Our Case Number: ABP-316272-23
Planning Authority Reference Number:

Re: Bus Connects Templeogue/Rathfarnham to City Centre Core Bus Corridor Scheme
Templeogue/Rathfarnham to City Centre

Bus Connects Submission to An Bord Pleanála in respect of the Templeogue/Rathfarnham to City Centre Core Bus Corridor

Bord Pleanála Case Reference: HA29N.316272

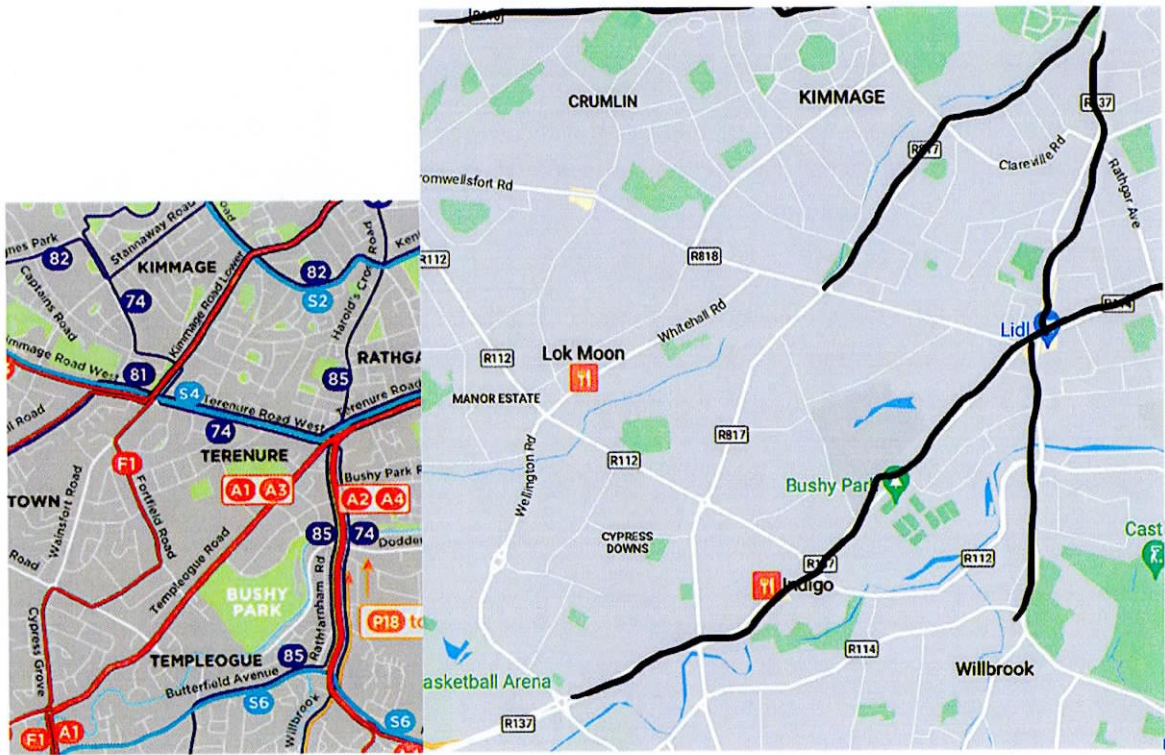
The map below with the black lines is drawn to demonstrate that a very small area is affected by the bus corridors, drawn in black lines, with the attendant bus gates. What is not drawn is the other changes and the increasing traffic in the peripheral roads. There is a heavy concentration of bus corridors influencing a small area outside of the city centre, this is unusual across the entirety of the network and creates a disproportionate burden on the communities living there.

The map with the F1 bus route shown below on Cypress Grove Road and Fortfield Road, shows the only viable alternative for access to the city centre, hospitals, etc for that area and it will be accompanied by all of the traffic that is diverted from the Bus Corridor under consideration and it will be limited by the Kimmage Bus Corridor, where the red line for the F1 thickens. As the surrounding roads are either not accessible at all because of a bus gate, or barred from access due to the implementation of a ban on right hand turns, this route will be overpopulated with traffic, and yet this is a significantly increased bus route. This might be bearable if it were during rush hour/peak traffic times only, but it isn't – it's from 6am to 8pm every day of the week. The timing of the bus gate is nonsensical and an unnecessary diminution of the quality of life of the residents in that area. Residents will have to drive much longer routes to gain access and egress from their roads and to access hospitals, doctors, dentists, schools and shopping areas.

Meanwhile the 54A bus route as it was, proposed now as the F1, will be removed from its route along Templeville Road, a cause of much distress to myself and other elderly residents on wainsfort road and

Grosvenor Court off Templeville Road, who until now have ease of access to this bus route. But under new plans will have to walk a considerable distance (which with my own mobility issues is unfeasible). This bus route will no longer travel the road outside Templeogue College, removing that direct connectivity up to a road running perpendicular to Templeville Road. Its route along the section of Templeville Road it traverses, Fortfield Park where there are two schools St Pius X boys and St Pius X girls national schools, Fortfield Road where there is Terenure College as well as the drop off for Our Lady's School on Templeogue Road and now no right hand turns into Greenlea Road or Lavarna Grove, will be clogged with the traffic that would have otherwise been able to travel along Templeogue Road. The traffic surveys carried out show that up to 7,404 vehicles that currently use Templeogue Road 300 of which is lorries, will be prohibited from so doing due to the bus gate. 1,440 vehicles will remain on Fortfield Road as they will be prohibited from going down Greenlea Road – that is how many vehicles will be trying to turn right towards the KCR now and causing that backlog of traffic. That is a considerable displacement from those two roads alone that will now be using the route alongside the F1 bus route. This alone demonstrates that the objective as set out will not be achieved for this section of road.
